**Addendum No. 1**

**Subject:** General Louis Wagner Middle School Culinary Art Suite Renovation  
SDP Contract Nos. B-022C, B-023C, B-024C, B-025C

**Location:** General Louis Wagner Middle School  
1701 W Chelton Ave  
Philadelphia, Pennsylvania 19139

**This Addendum, dated 1 of April, 2021, shall modify and become part of the Contract Documents for the work of this project. Any items not mentioned herein, or affected by, shall be performed strictly in accordance with the original documents.**

DRAWING NO.  
**A-301**  
SHEET 5 OF 23

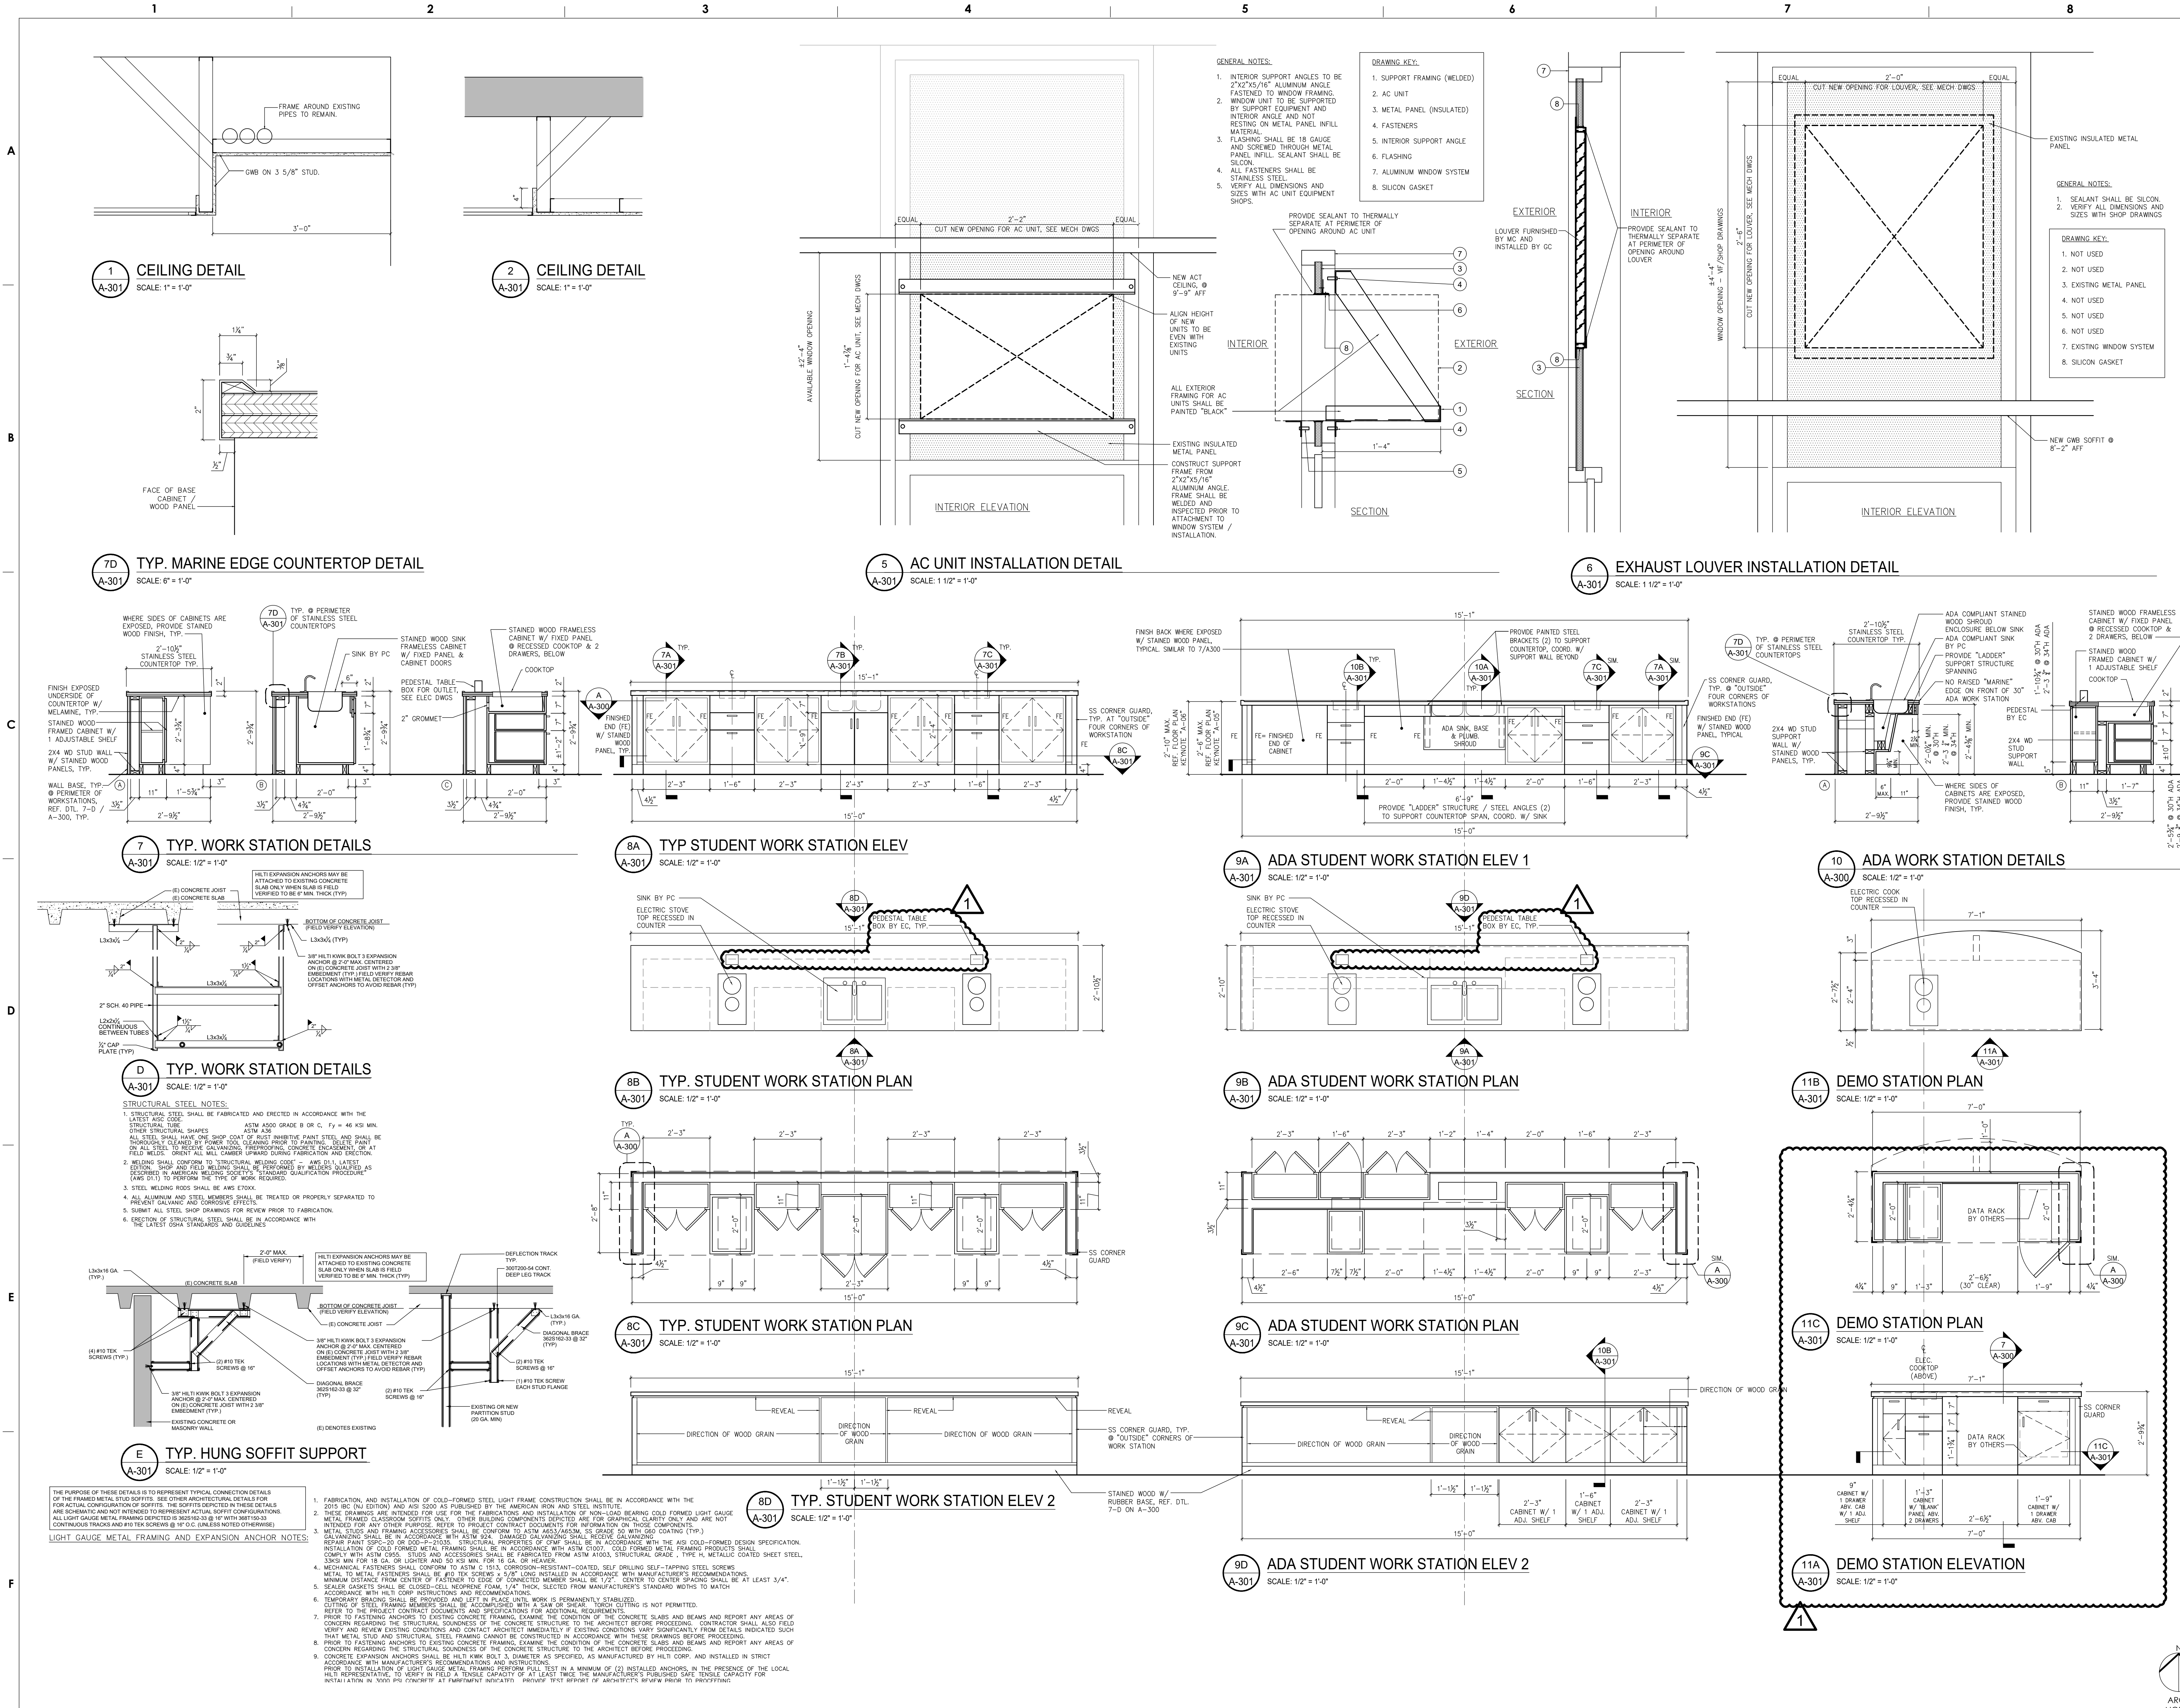
**Drawing: A-301 Millwork, Ceiling, and Window Details**

- a. Detail 8B/A-301 – Typ. Student Work Station Plan, pedestal table locations added, refer to revised drawings
- b. Detail 9B/A-301 – ADA Student Work Station Plan, pedestal table locations added, refer to revised drawings

- c. Detail 11C/A-301 – Demo Station Plan and Detail 11A/A-301 – Demo Station Elevation, cabinets reconfigured due to addition of data rack by others, refer to revised drawings.

Question 17: Will the stainless steel counter be provided with holes for the pedestal receptacle boxes?

**Answer 17: Yes, holes shall be provided for pedestal receptacle boxes. See revised details 8B and 9B on sheet A-301.**

DRAWING NO.  
**A-700**  
SHEET 6 OF 23

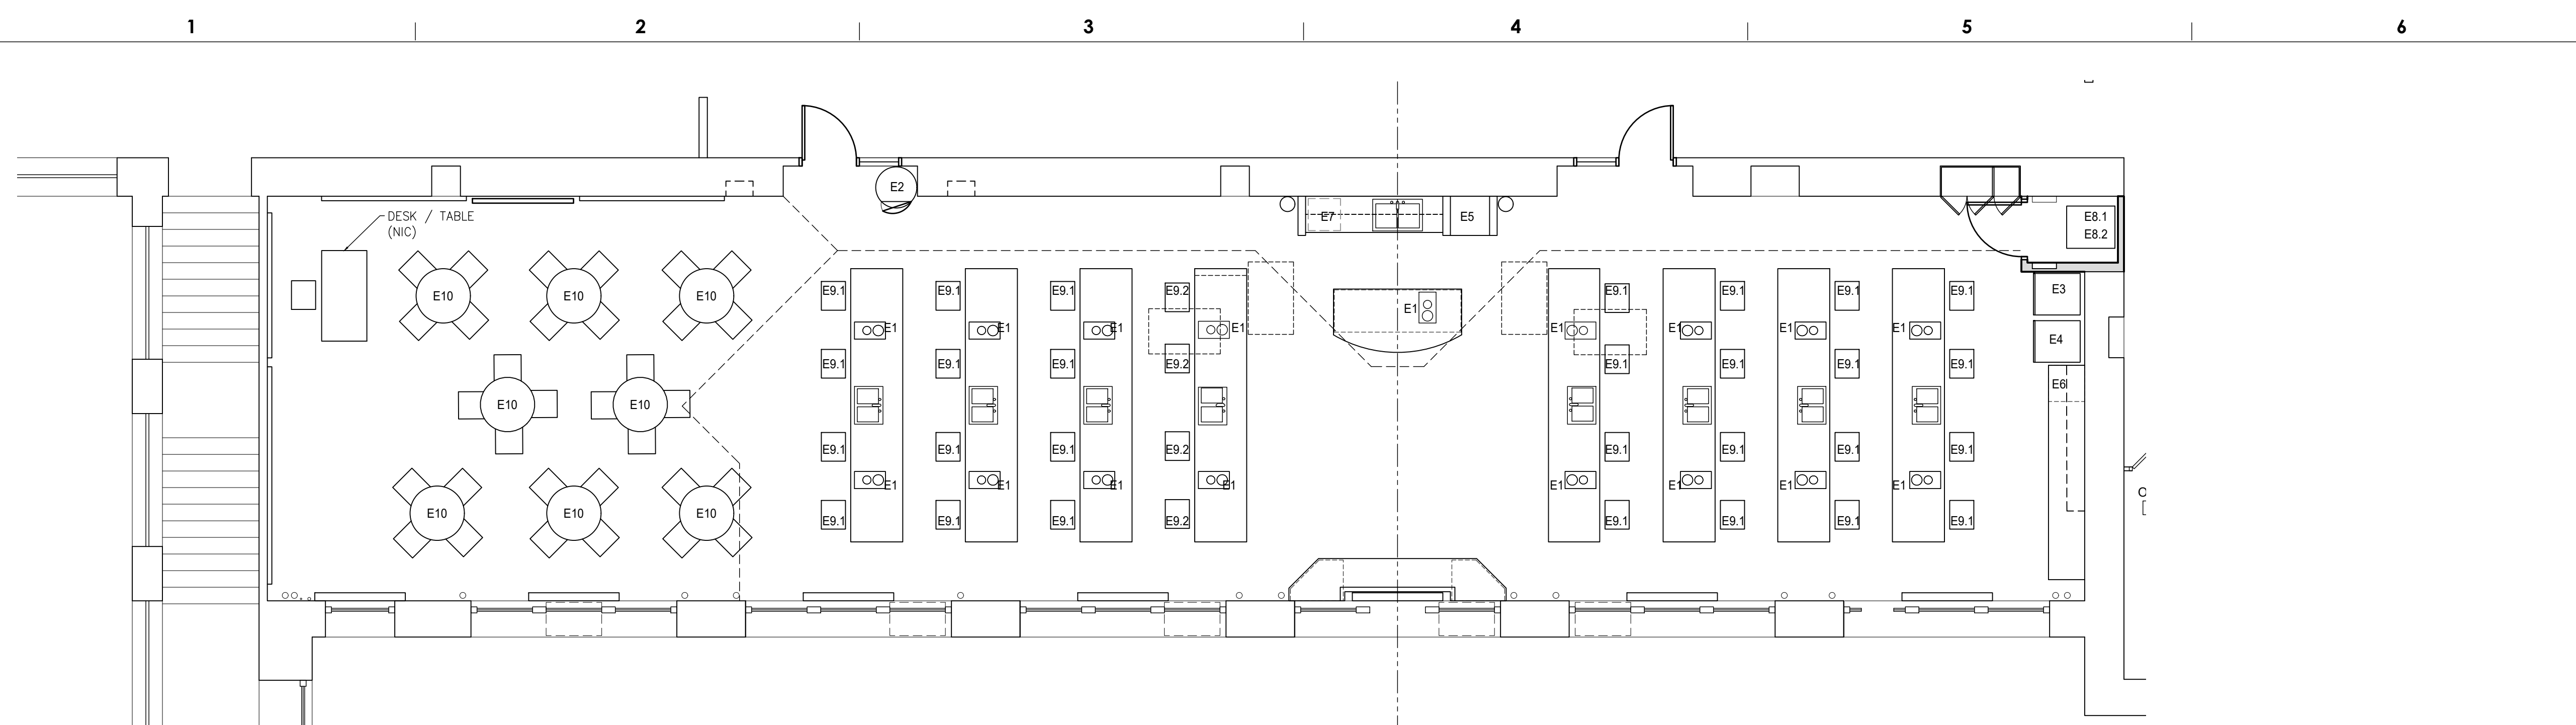
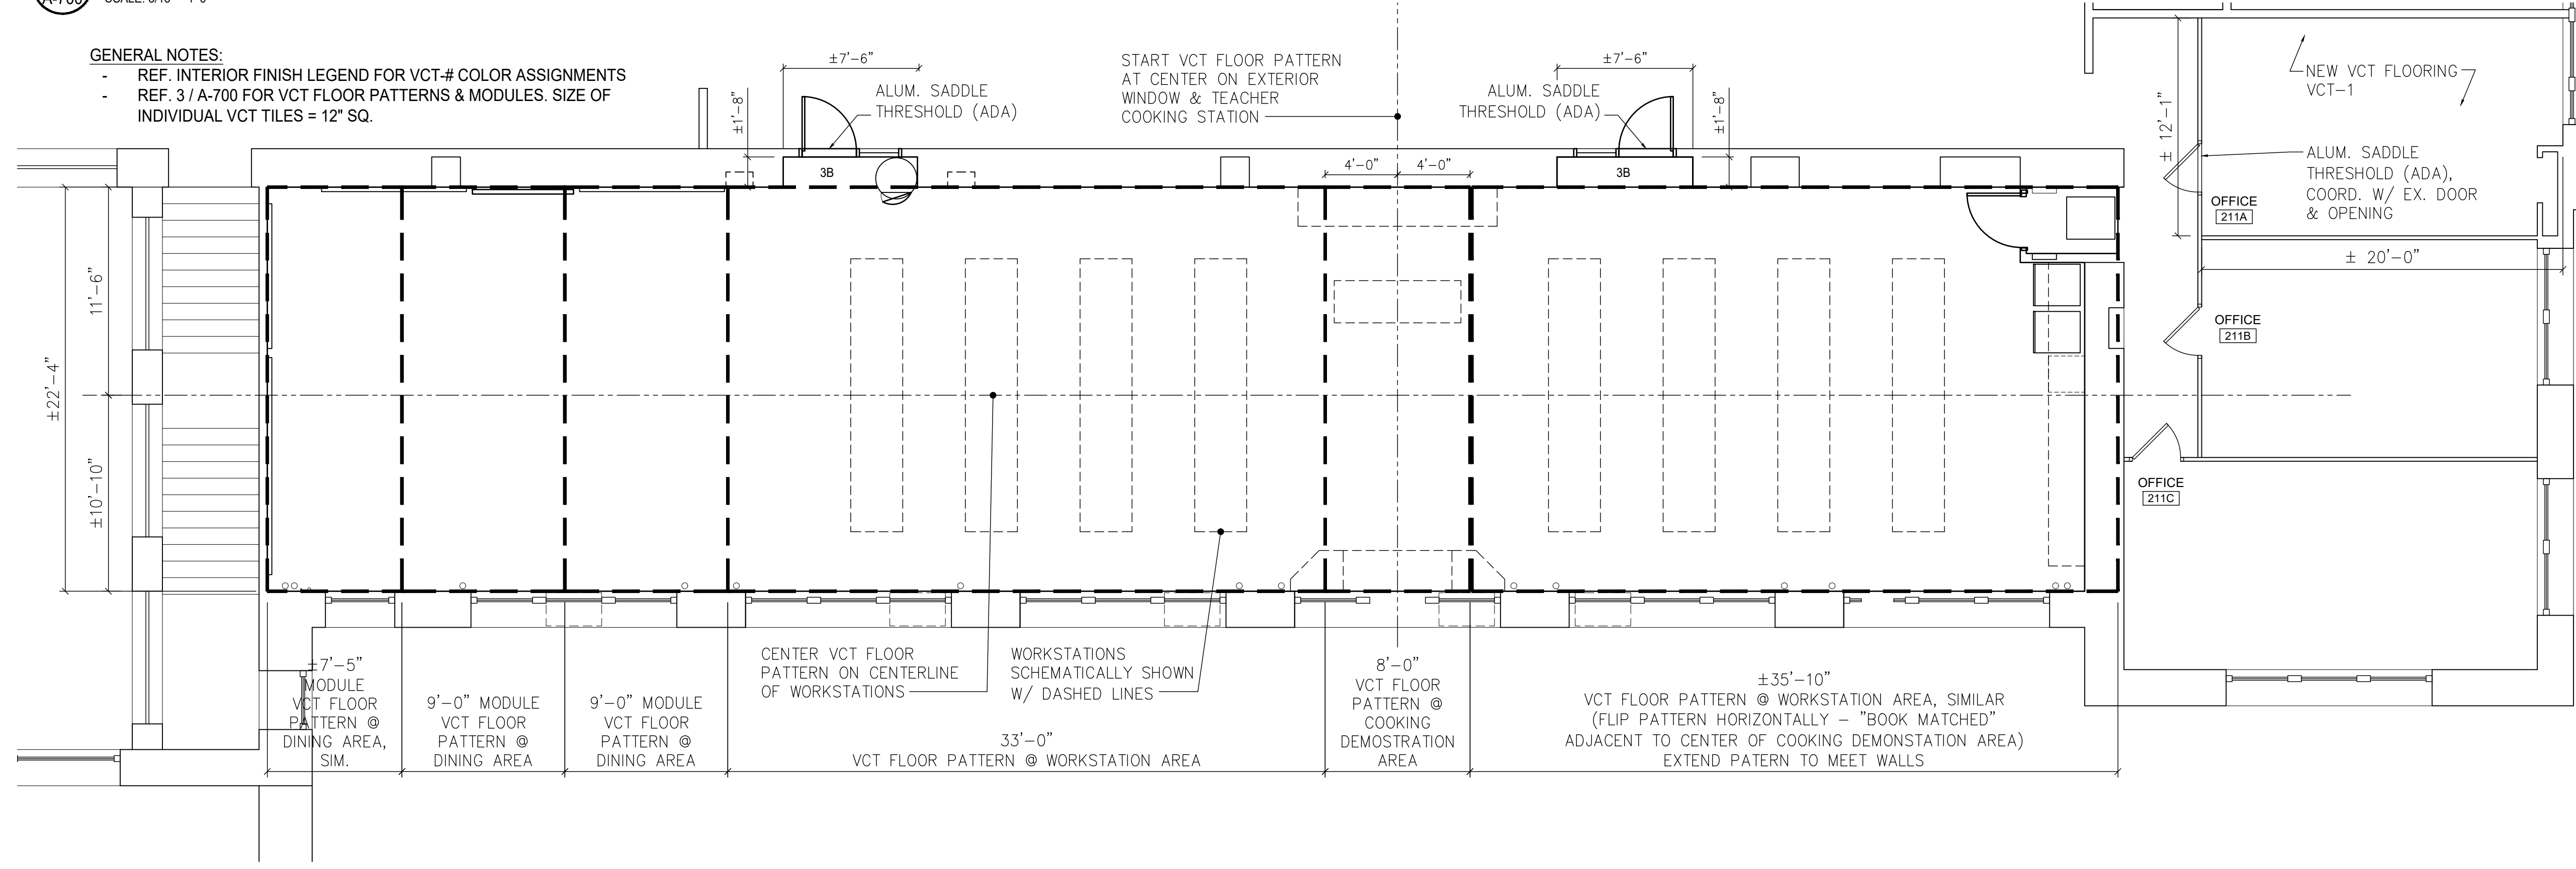
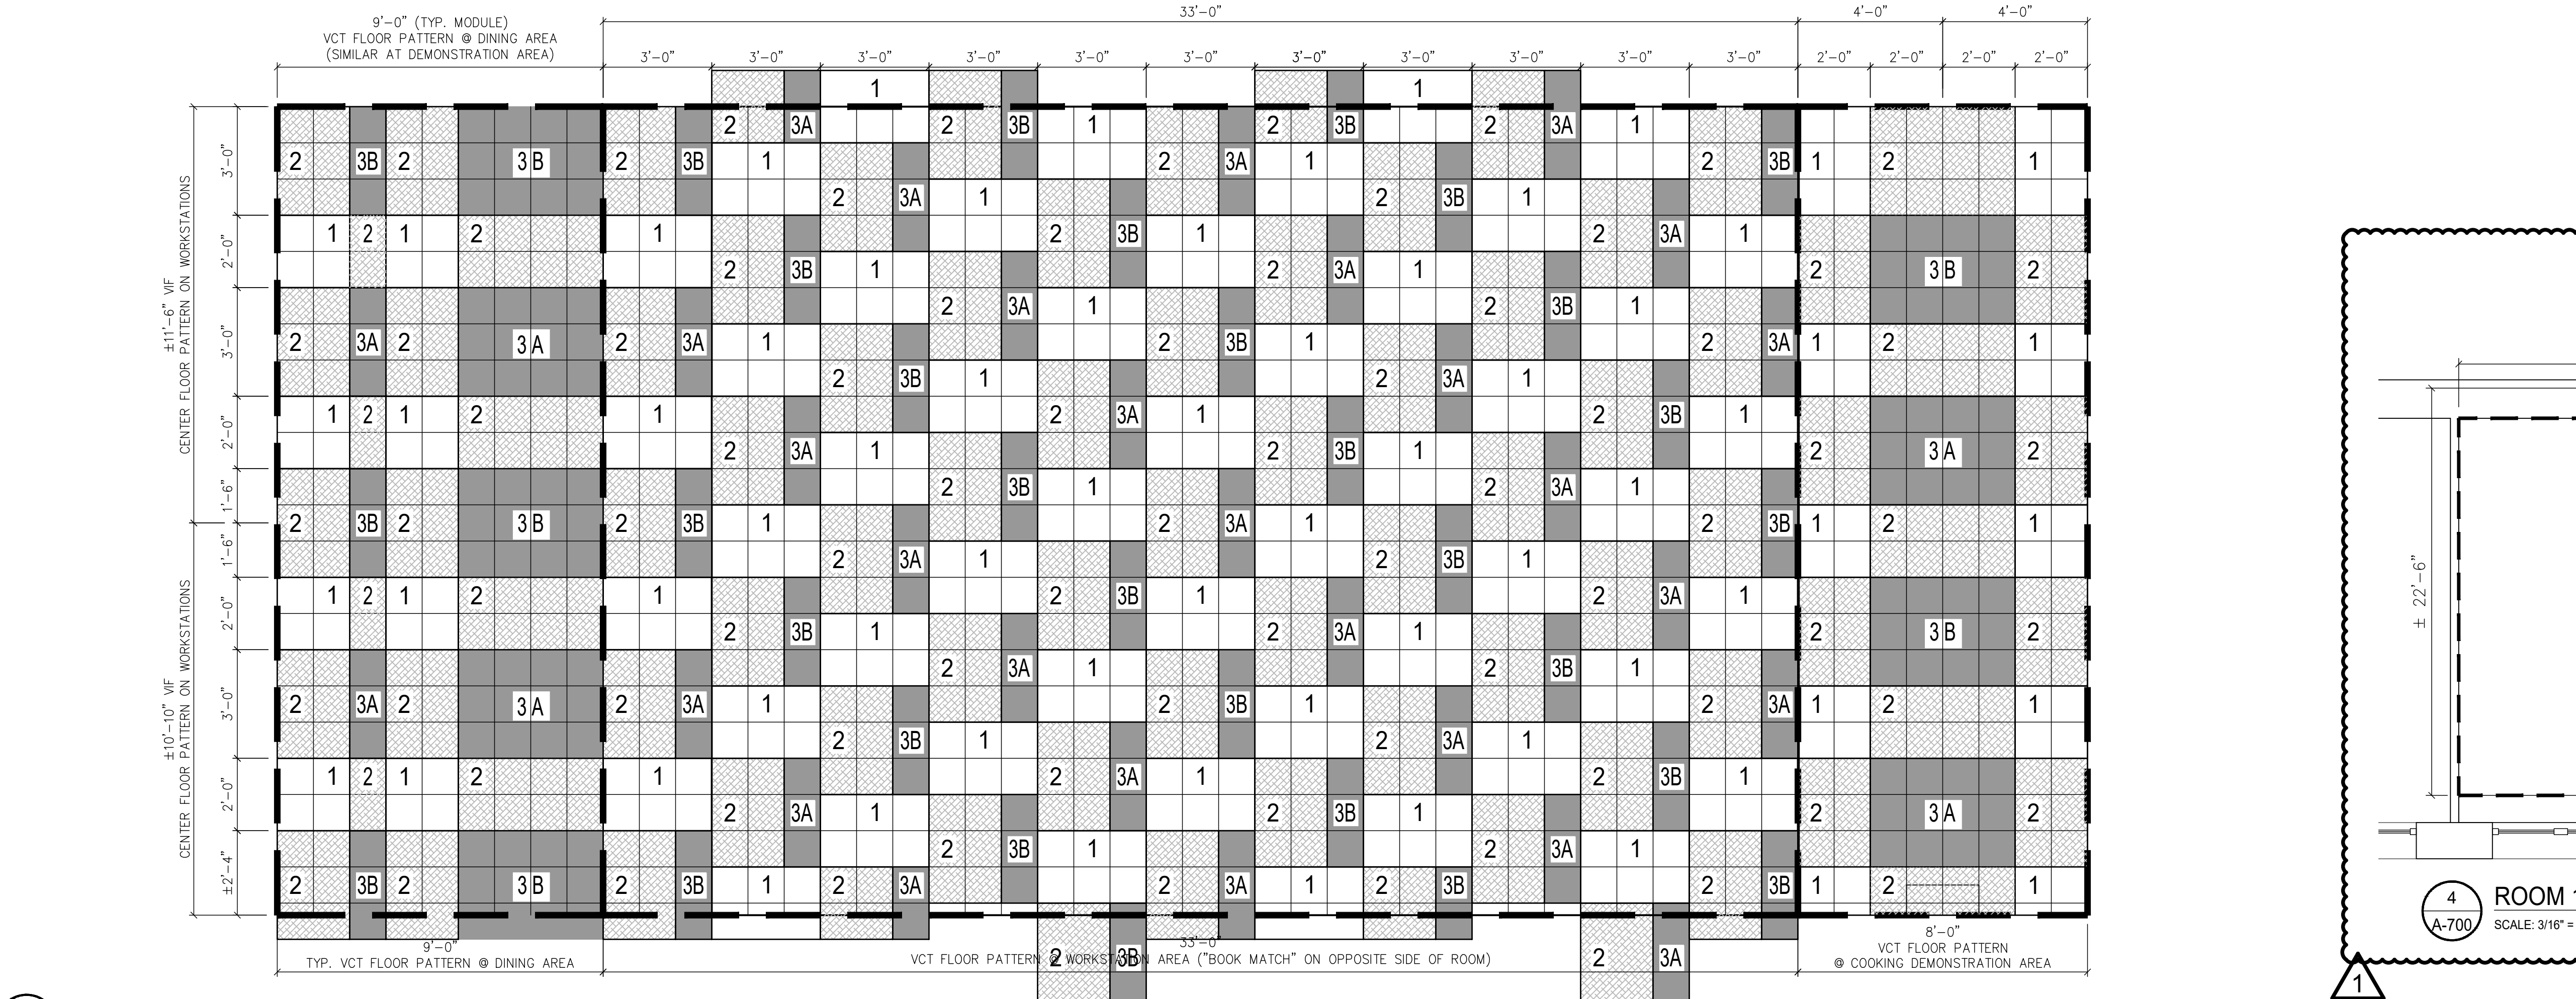
#### **Drawing: A-700 Finish, Furniture, and Equipment Plans**

- a. Add new detail: Detail 4 / A-700- Room 105 Finish Plan, refer to revised drawing.

Question 4: Asbestos report has floor in room 105&106 being removed, but not shown on finish schedule to replace with new VCT.

Question 5: Are the appliances listed on drawing part of GC scope of work?

**Answer 4: New VCT is to be provided for Room 105, see detail 4 on revised sheet A. Please note flooring in Room 106 has already been replaced and is to remain.**

**Answer 5: Yes, appliances listed on A-700 are part of GC scope of work.**
